COLUMBIA COUNTY PLANNING COMMISSION

COLUMBIA COUNTY LAND DEVELOPMENT SERVICES
STAFF REPORT
September 20, 2023
Site Design Review- Type 2

FILE NUMBER: DR 24-01

REQUEST: To construct new structures and facilities for the Columbia County Christian School.

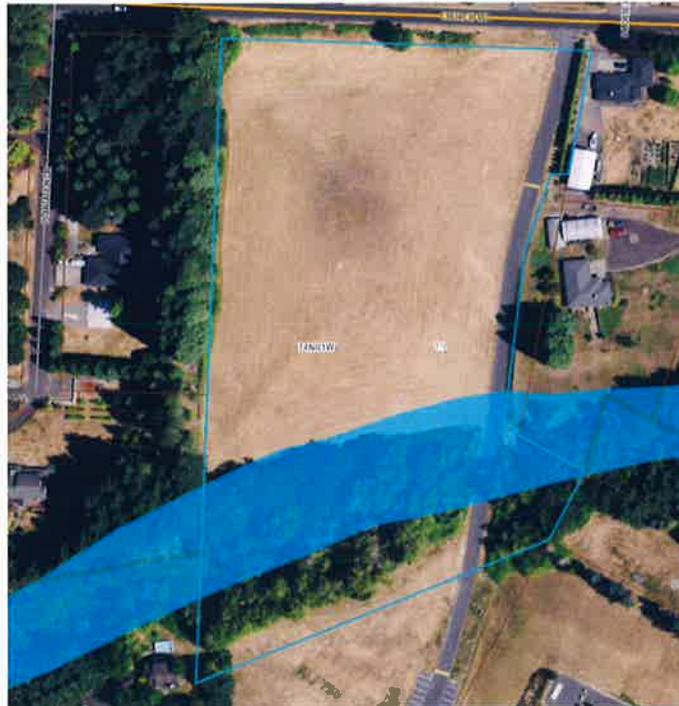
Finding 12: Although the subject property contains areas located within Flood Hazard Zone A, this is limited to the area directly surrounding Warren Creek.

No development is proposed within this flood hazard area. Therefore, the criteria of Section 1100 do not apply to this application.

ODF Streams & DSL Wetlands Map

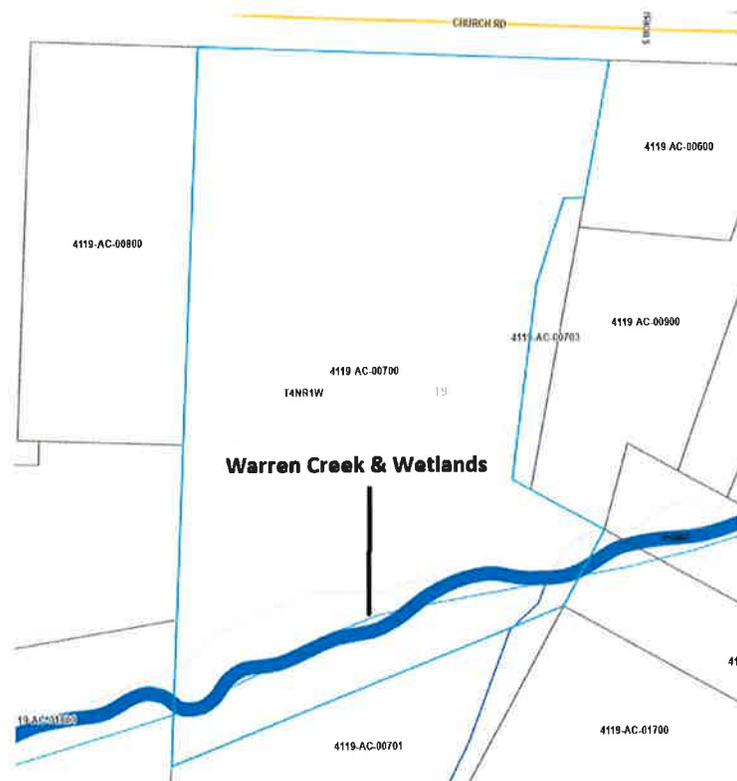
Finding 13: According to the Oregon Department of Forestry (ODF) Streams map and the Oregon Department of State Lands (DSL) Wetlands Inventory map, the subject property contains an identified fish-bearing stream (Warren Creek) with associated identified wetlands.

Per the criteria of subsection 1172.2 and 1172.5, there is a 50' protected Riparian Corridor extending from the top-of-bank of Warren Creek and from the upland edge of associated identified wetlands. The submitted site plan indicates that all structures will be greater than 100' from the top of the creek bank. To ensure compliance as the project progresses, a condition of approval will state that a 50' riparian corridor shall be maintained from the top of the stream's bank and the upland edge of the associated identified wetlands.

SHEET
C-5

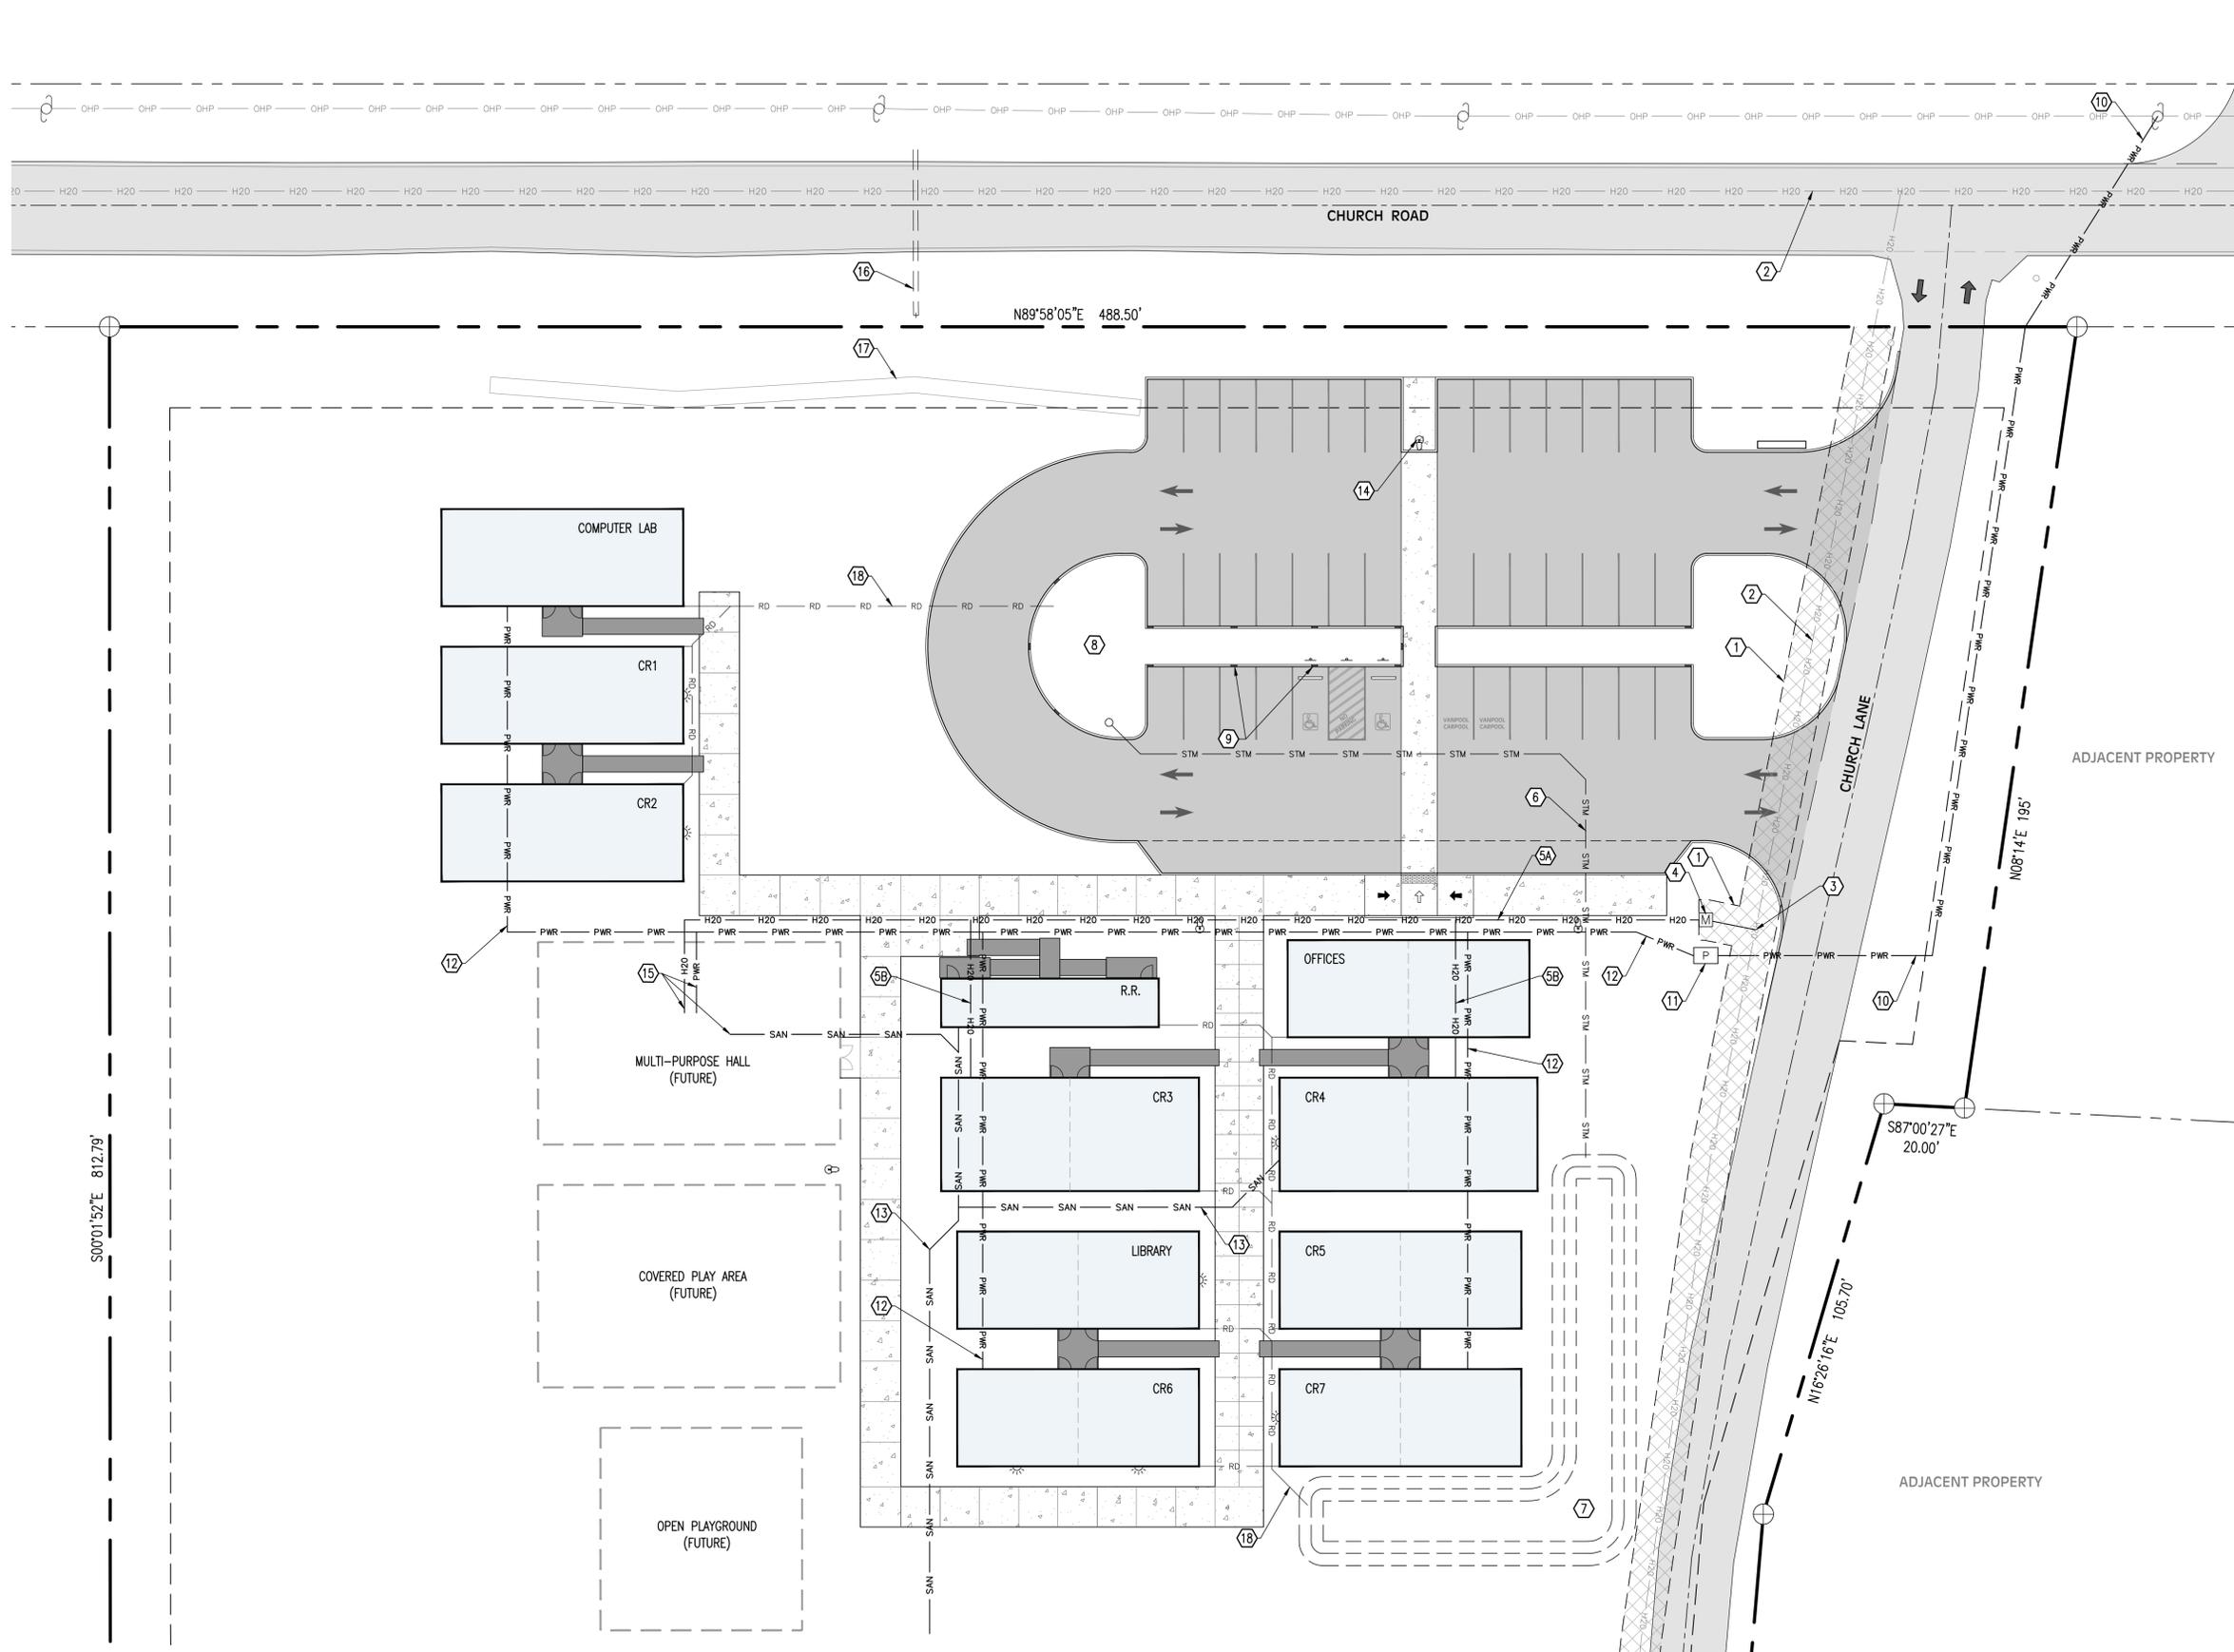
Finding 41: The applicant's Parking and Landscaping plan details a 13' wide buffer area between the proposed parking lot and the property's north parcel line along Church Road. Church Road separates this institutional use from residential-zoned properties, which are additionally found to the east and west of the subject property. The buffer area along Church Road will consist of screening trees every 12' and screening shrubs every 5'. These trees will be 8' tall, meeting the 5' minimum requirement. No parking, utility, or structures are proposed for this buffer area. Additional screening requirements are not applicable to this buffer area as Church Road separates the subject property from differing adjacent uses.

Response: Please see the Parking & Landscape Plan (Sheet C-5). A 13-foot-wide buffer area is proposed between the new parking lot and the property line along Church Road. Within this buffer area, screening trees (Northern White Cedar) are proposed every 12-feet and screening shrubs (Oregon Grape) are proposed every 5-feet. No parking areas, utility lines, or buildings are proposed within the buffer area. Therefore, these standards are met.

SHEET
C-8

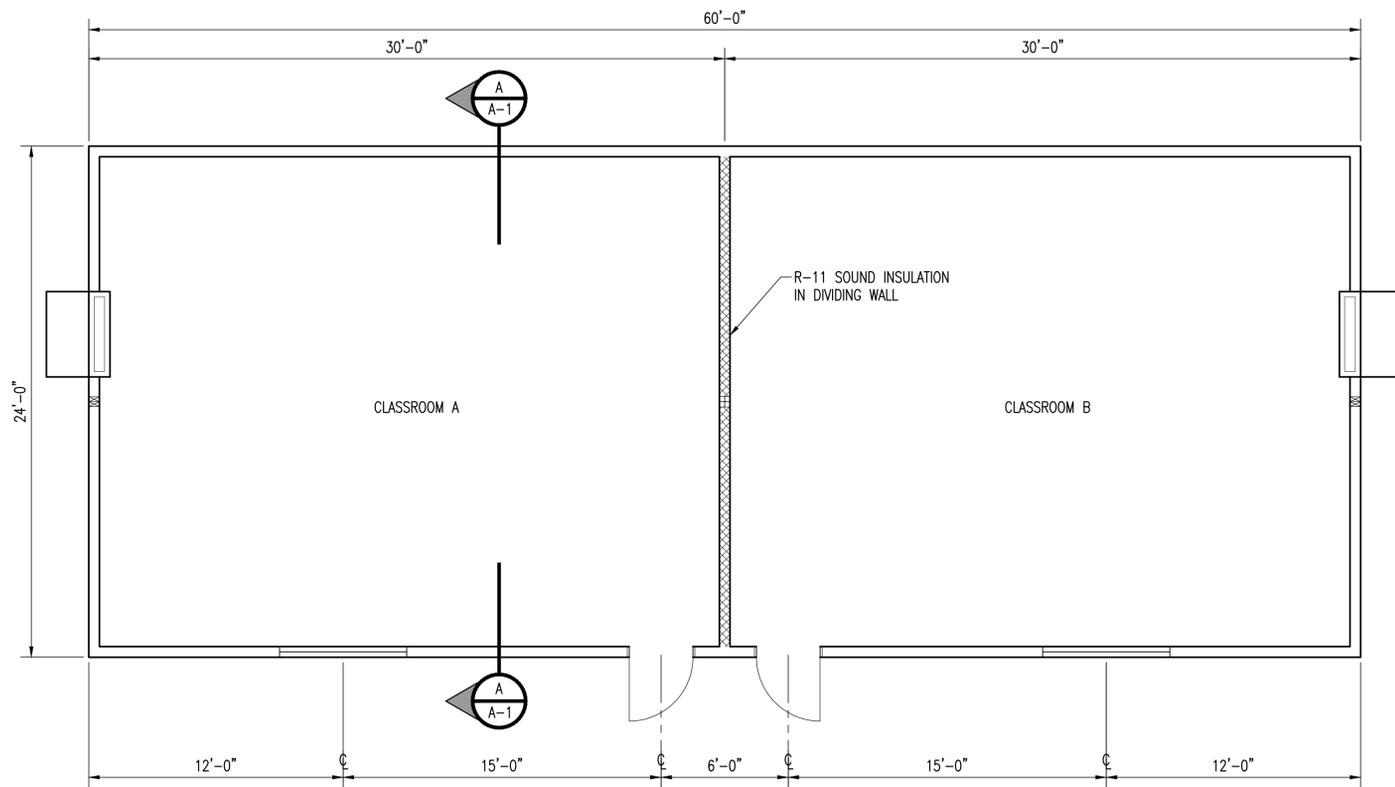
2. The application states that CCZO Section 1302.2(D) has not been met and that the requirement is "impractical". The submitted narrative states that a sign is being proposed approximately 14' from the north property line, however the submitted design plan sheet C3.I show this sign to be less than 10' from the north property line. If the proposal does not conform to the required 30' setback stated in CCZO 1302.2(D), the applicant shall submit a variance proposal concurrently with the Design Review.

Response: Please see updated Enlarged Site Plan (Sheet C-3.1) and updated narrative responses to CCZO Section 1302.2. The sign has been moved to a location a minimum of 30-feet away from the northern property line. If the proposed sign location is not acceptable for any other reason, the applicant will apply for a sign permit and variance in a separate application at a later date.
